**LEBANON PLANNING BOARD
FEBRUARY 12, 2024 - 6:30 PM
COUNCIL CHAMBERS, CITY HALL OR
REMOTE VIA VIRTUAL PLATFORM
LEBANONNH.GOV/LIVE**

Staff Memorandum – PB2024-05-SPA

Oakes Storage, LLC and Oakes Real Estate SPE, LLC, 92 Riverside Drive (Tax Map 111, Lot 16), zoned RL-1: Pursuant to Section 9.1 of the Site Plan Review Regulations, applicants request a modification to a previously approved Site Plan (PB2022-06-SPR) to construct a +/-26,176 sq. ft. commercial self-storage unit facility together with related site improvements. Applicants propose to lower the site 4 ft. and to relocate the garage and entry drive. PB2024-05-SPA

SITE PLAN

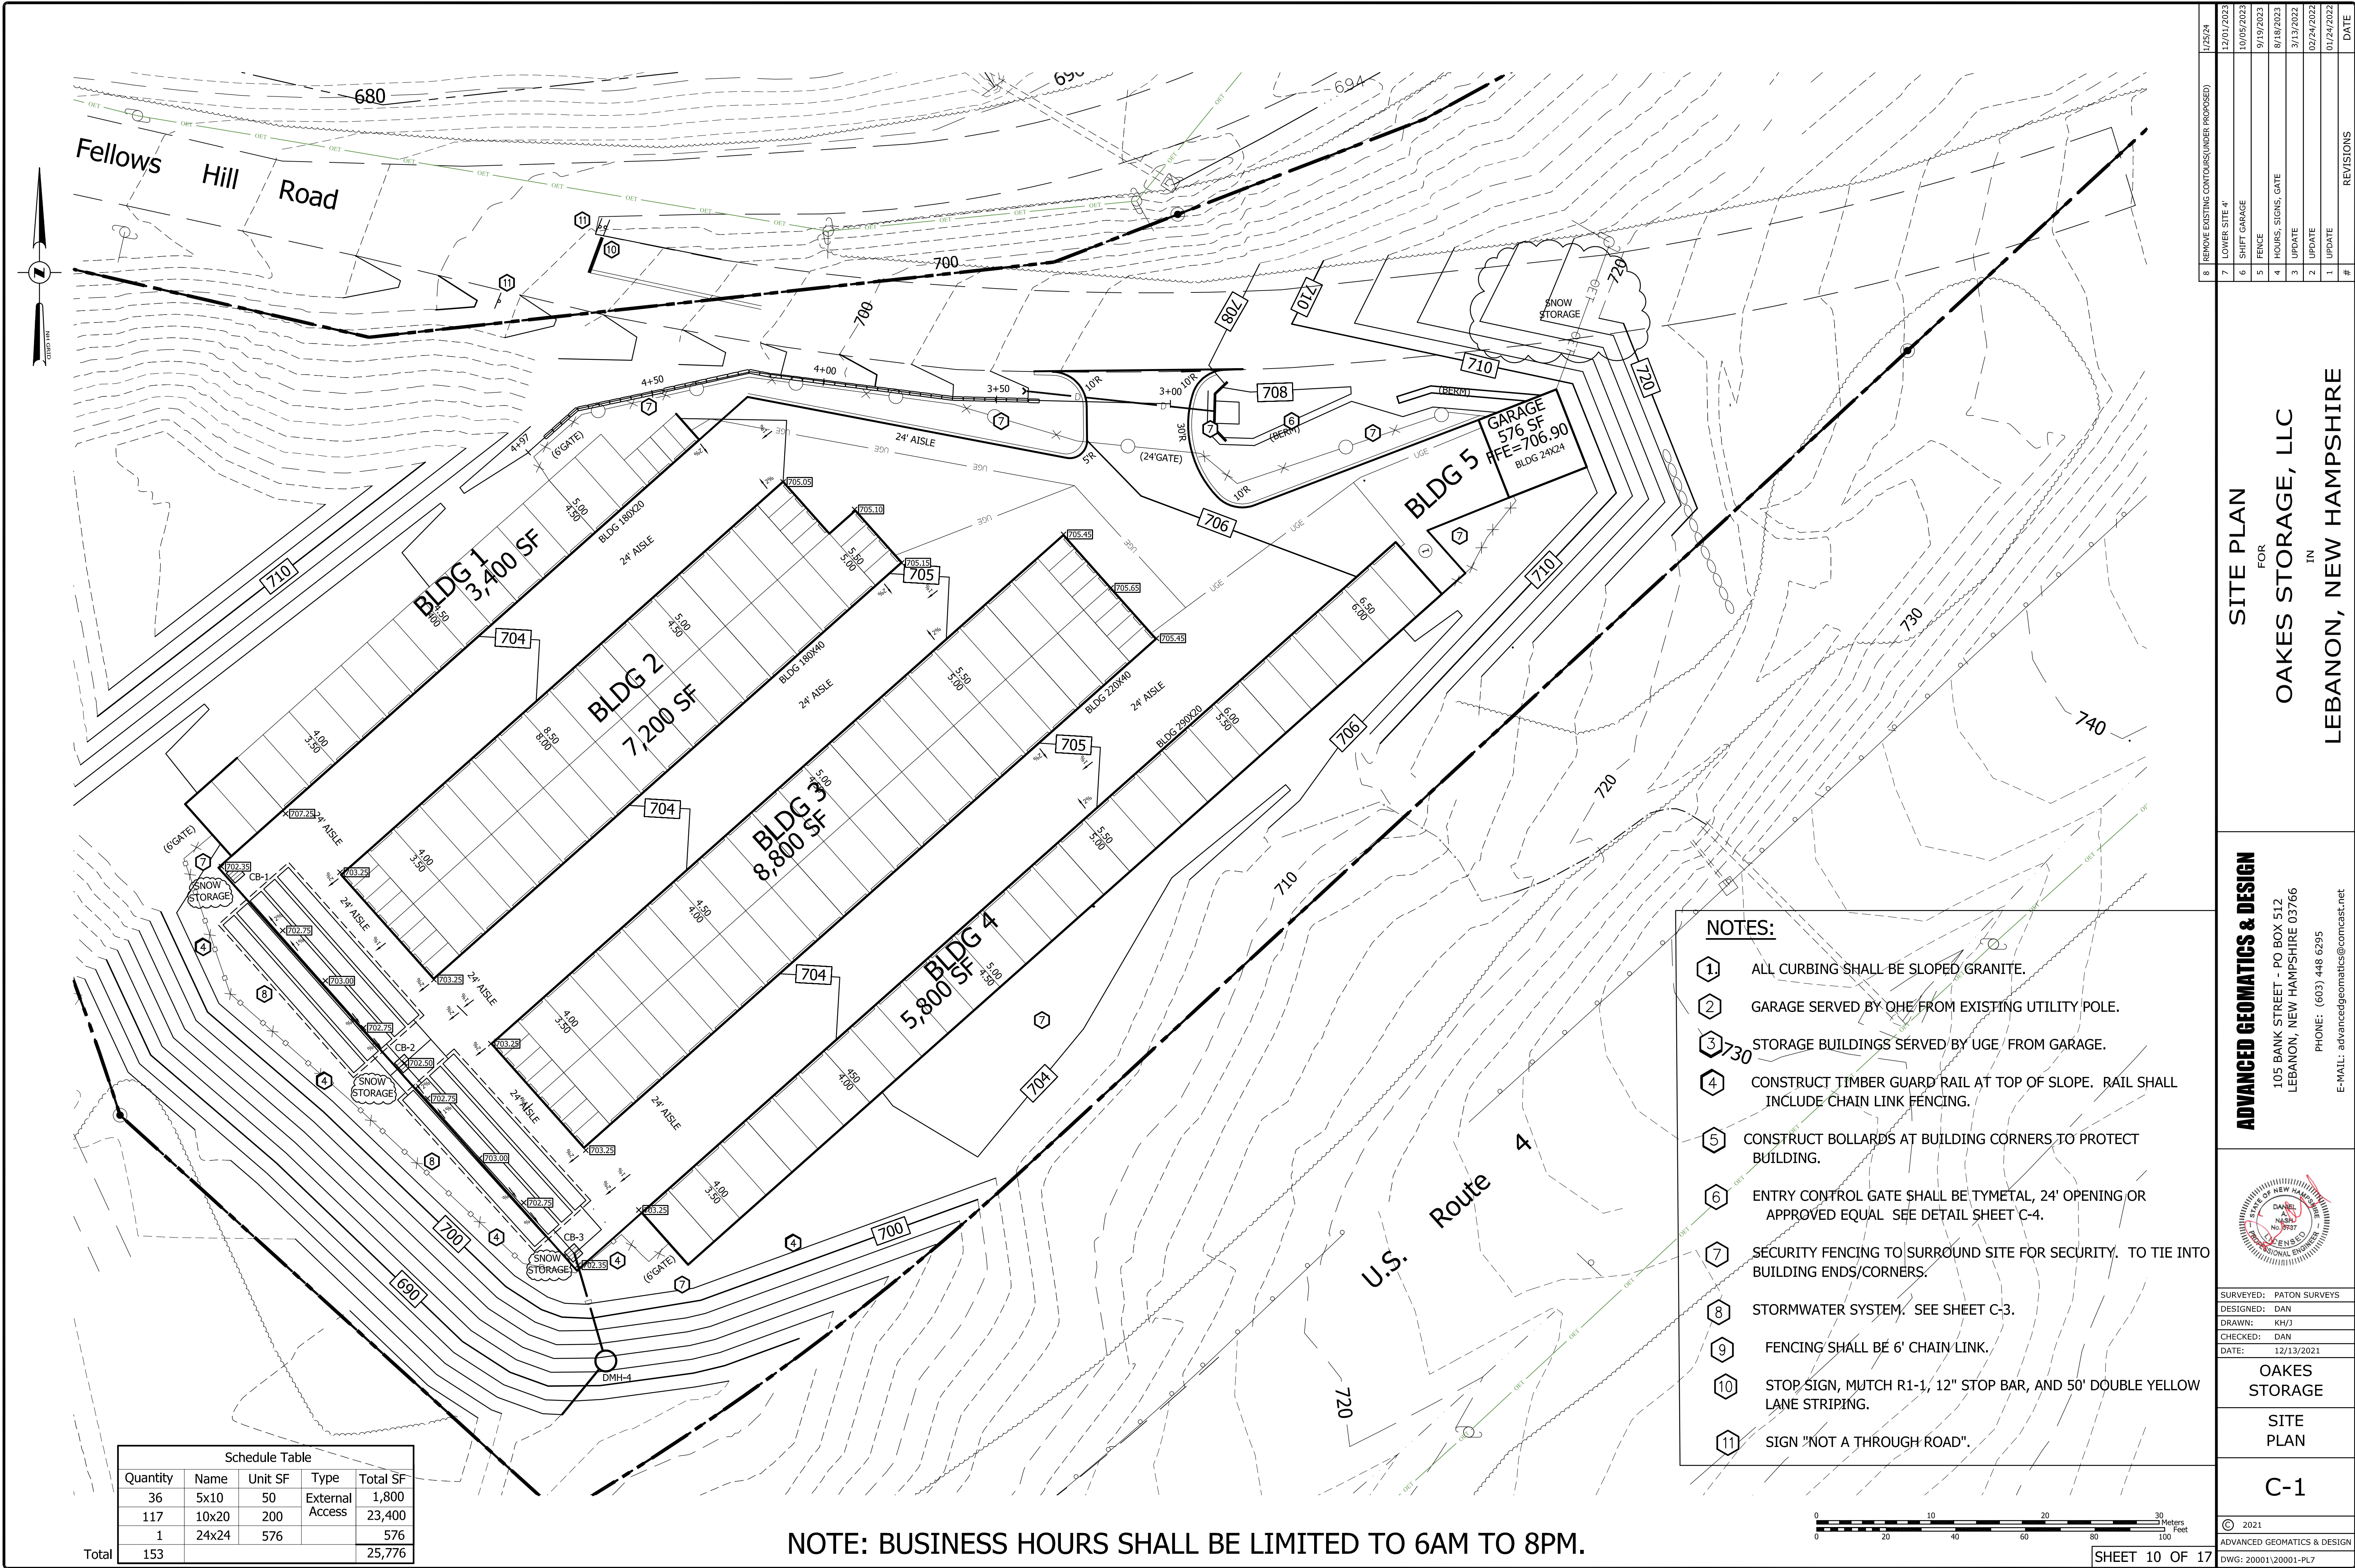
Just prior to site work commencing, a conflict between site plans and the Geotech report surfaced. The Geotech report requires that the site be lowered 4' from the grades that were approved on the site plan. In addition, the building inspector directed that the garage be shifted to be a minimum of 30' from the storage buildings; the garage has been placed 35' away. In lowering the site, the driveway had to be shifted slightly downhill. These changes are reflected on the attached plan.

DATE	REVISIONS	#
12/24/2022	1. UPDATE	1
02/24/2022	2. UPDATE	2
3/13/2022	3. UPDATE	3
8/18/2023	4. HOURS, SIGNS, GATE	4
9/19/2023	5. FENCE	5
10/05/2023	6. SHIFT GARAGE	6
12/01/2023	7. LOWER SITE 4'	7
1/25/24	8. REMOVE EXISTING CONTOURS(UNUSE PROPOSED)	8

DETAILED GRADING PLAN
FOR
OAKES STORAGE, LLC
IN
LEBANON, NEW HAMPSHIRE

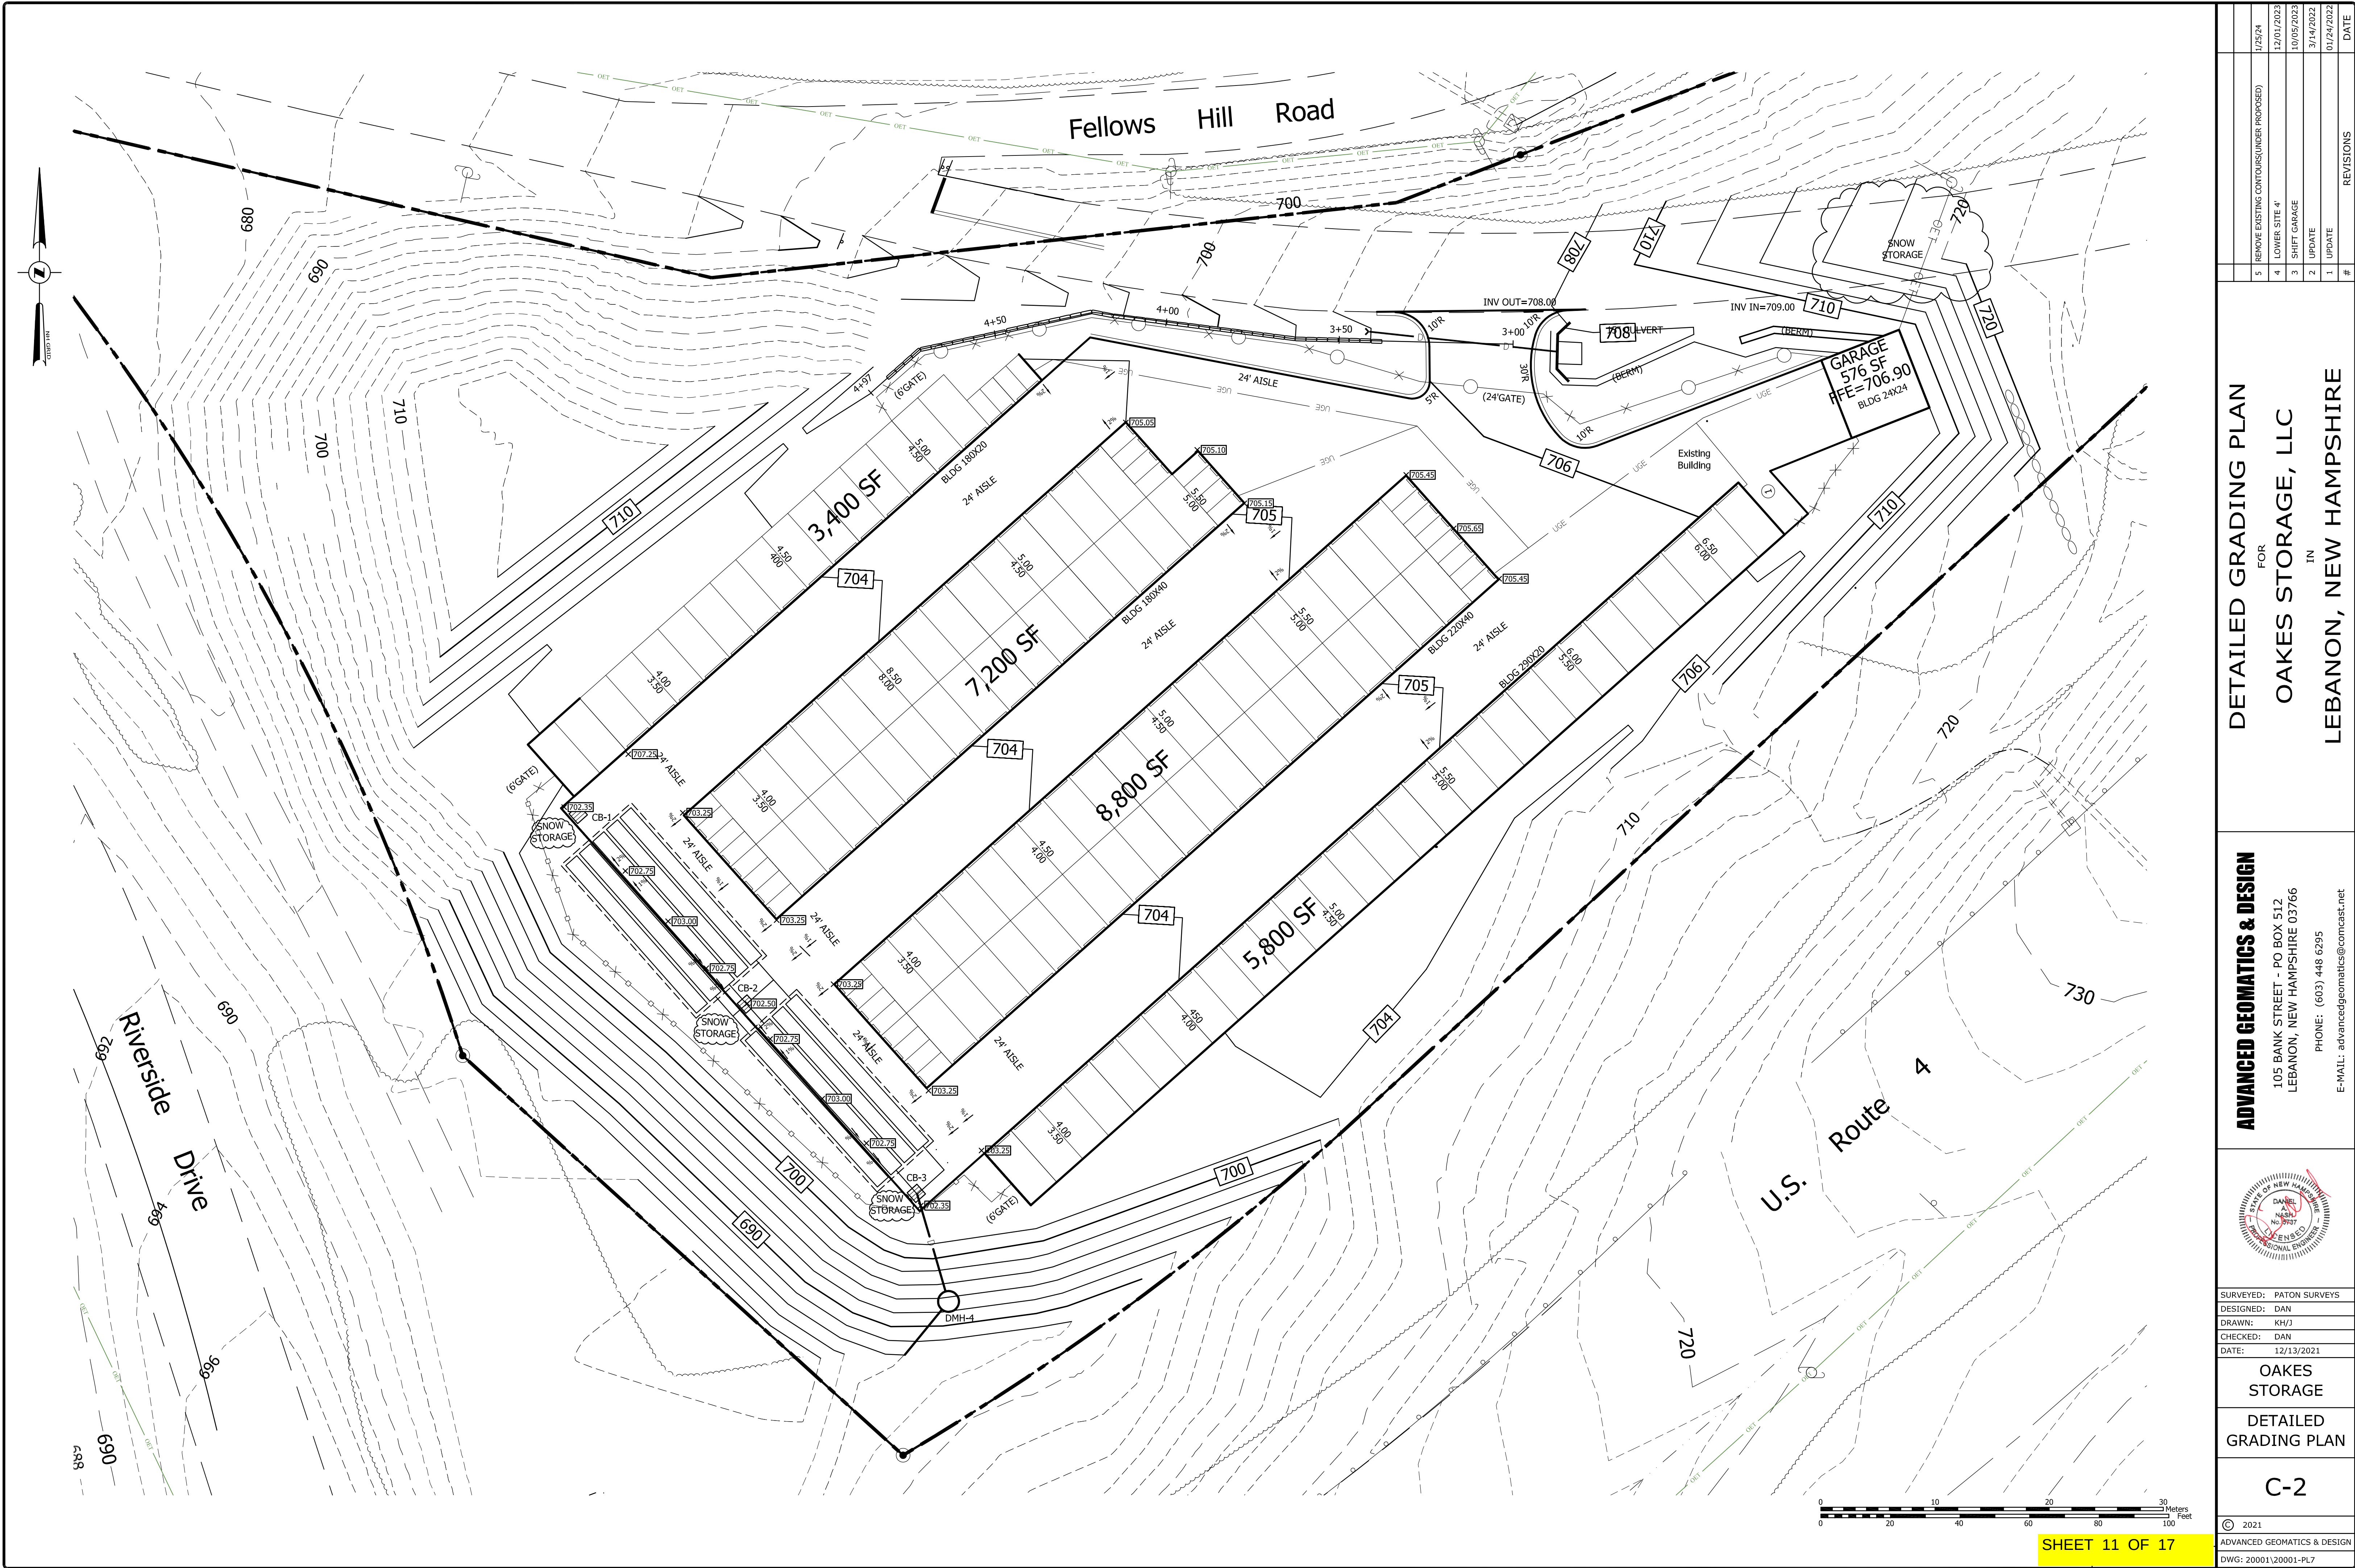
#	REVISIONS	DATE
5	REMOVE EXISTING CONTOURS (UNDER PROPOSED)	1/25/24
4	LOWER SITE 4	12/01/2023
3	SHIFT GARAGE	10/05/2023
2	UPDATE	3/14/2022
1	UPDATE	01/24/2022
